# Field Safety Notice

Affected Device  
 medin-NC3 (REF 3000)  
 Medin Reference ID: MEDIN-FSN-2026-001  
 BfArM Nr: 30339/26  
 FIMEA Reference ID: P3732

Fig. 1 – Device alarm message placeholder

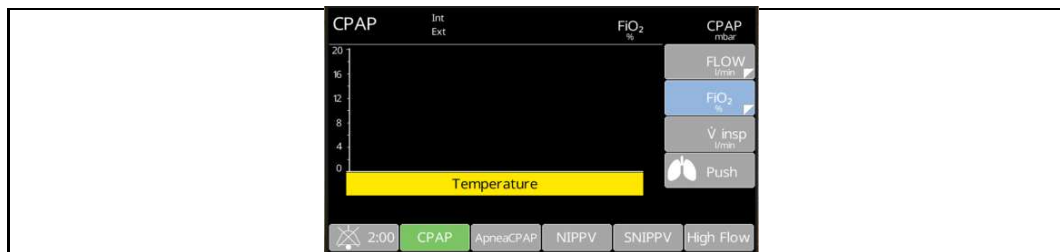
medin has identified that medin-NC3 devices equipped with HY-LINE H2B665 battery operated with software below CPU V1.2, Display V111 and Pneumatic A14.00 may issue a medium-priority temperature alarm. The exact alarm name / device alarm text is: **“Temperature”**.

The alarm condition may occur during operation when the new internal battery type HY-LINE H2B665 is installed without the corresponding software update. Based on medin’s technical assessment to date, the alarm is a false / nuisance temperature alarm and does not indicate confirmed overheating of the device.

**Identified root cause:** the affected battery type requires the corrected software configuration to monitor and interpret the relevant battery parameters correctly. Older software versions do not fully support this battery configuration and may therefore trigger the temperature alarm although the device is not actually overheating.

| <b>Required corrected configuration</b> | Devices equipped with the HY-LINE H2B665 battery shall be operated with CPU software version V1.2 or later, Display software version V111 or later, and Pneumatic software version A14.00 or later. |
